Project	<b>IEEE 802.16 Broadband Wireless Access Working Group</b> < <a href="http://ieee802.org/16">http://ieee802.org/16</a> >	
Title	<b>CBC Mode and Initial Vector for the AES algorithm</b>	
Data Submitted	<b>2004-11-04</b>	
Source(s)	Sungcheol Chang Jaesun Cha Seokheon Cho Chulsik Yoon  ETRI 161, Gajeong-dong, Yuseong-Gu, Daejeon, 305-350, Korea	Voice: +82-42-860-5456 Fax: +82-42-861-1966 <a href="mailto:scchang@etri.re.kr">scchang@etri.re.kr</a> <a href="mailto:chosh@etri.re.kr">chosh@etri.re.kr</a> <a href="mailto:jscha@etri.re.kr">jscha@etri.re.kr</a>
Re:	This is a response to Sponsor Ballot 16e on P802.16e/D5..	
Abstract	The document contains suggestions on the changes in IEEE P802.16e-D1 that would support efficient key management method for the multicast service.	
Purpose	The document is submitted for review by 802.16 Working Group members.	
Notice	This document has been prepared to assist IEEE 802.16. It is offered as a basis for discussion and is not binding on the contributing individual(s) or organization(s). The material in this document is subject to change in form and content after further study. The contributor(s) reserve(s) the right to add, amend or withdraw mat

Figure xxx – CBC IV generation.

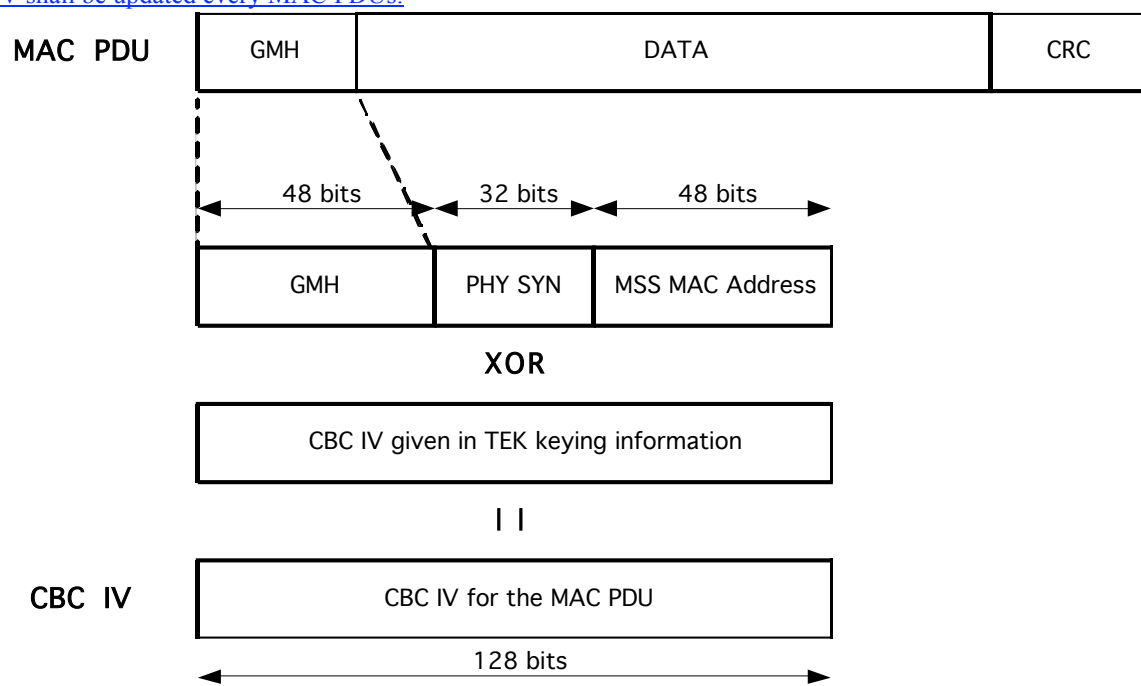
[Add section 7.8.2.3 in page 149 as follows]

### 7.8.2.3 Data encryption with AES in CBC mode

If the data encryption algorithm identifier in the cryptographic suite of an SA equals 0x03, data on connections associated with that SA shall use the CBC mode of the US Advanced Encryption Standard (AES) algorithm [NIST Special Publication 800-38C, FIPS 197] to encrypt the MAC PDU payloads.

#### 7.8.2.3.1 CBC IV generation

The CBC IV shall be calculated with the exclusive-or (XOR) of (1) the IV parameter included in the TEK keying information, and (2) the 128-bits content which is a concatenation of the 48-bit MAC PDU Header, the 32-bit PHY Synchronization value of the MAP that a data transmission occurs, and the 48-bit MSS MAC address.

The CBC IV shall be updated every MAC PDUs.

If the MAC PDU is decoded from several channel coded blocks transmitted at different frames in HARQ operation, the MAC PDU payload must be decrypted with the CBC IV value which are generated from the PHY Synchronization value of the MAP when spid=0.
